Certificate of Appropriateness for
1825 Van Hise Ave.

June 17, 2019

7 PROPOSED DESIGN
Scale: 1/8" = 1'-0"

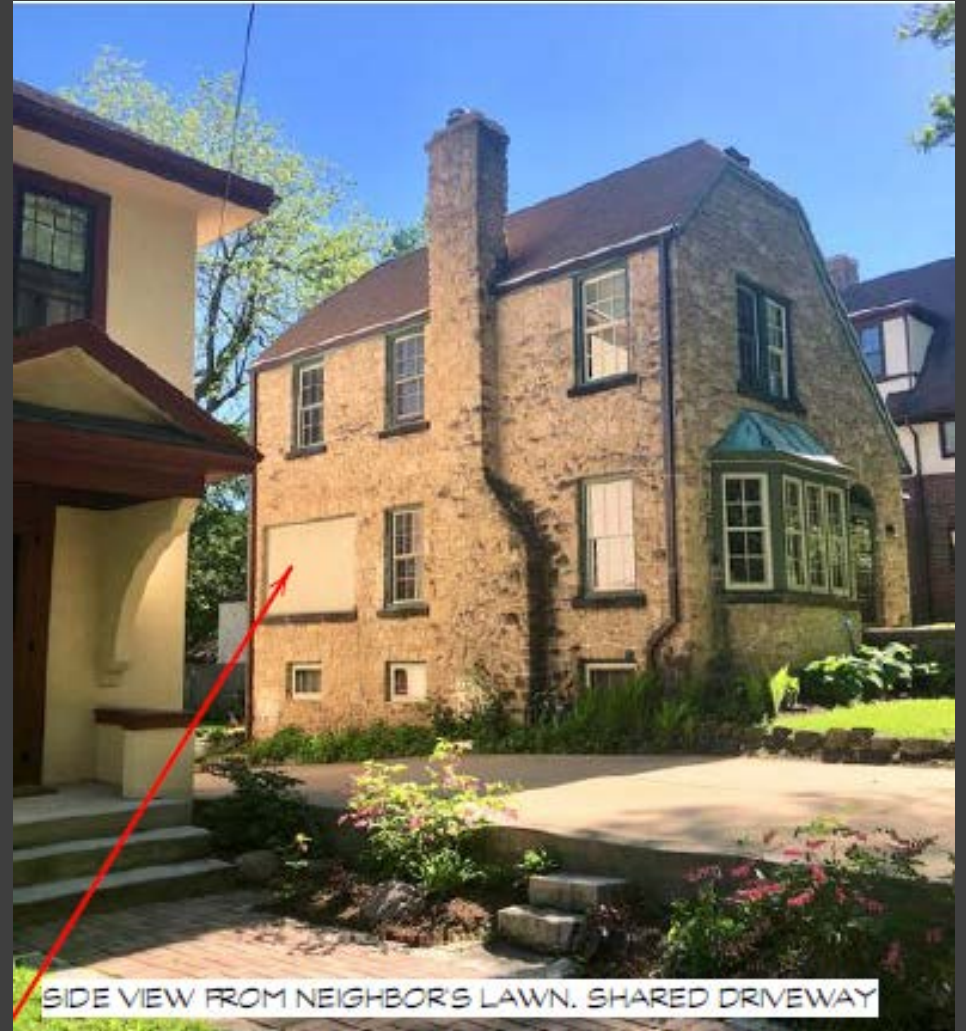
→ RESTORE THIS WINDOW OPENING BY INSTALLING NEW DOUBLE HUNG WINDOWS TO MATCH EXISTING

Staff believes that the standards for granting a Certificate of Appropriateness may be met and recommends the Landmarks Commission approve the proposal with the following conditions:

1. Deck flooring specifications be approved by staff.
2. Deck railing be of the same style as proposed, but be constructed of either wood or a compatible wood substitute as determined by the commission.
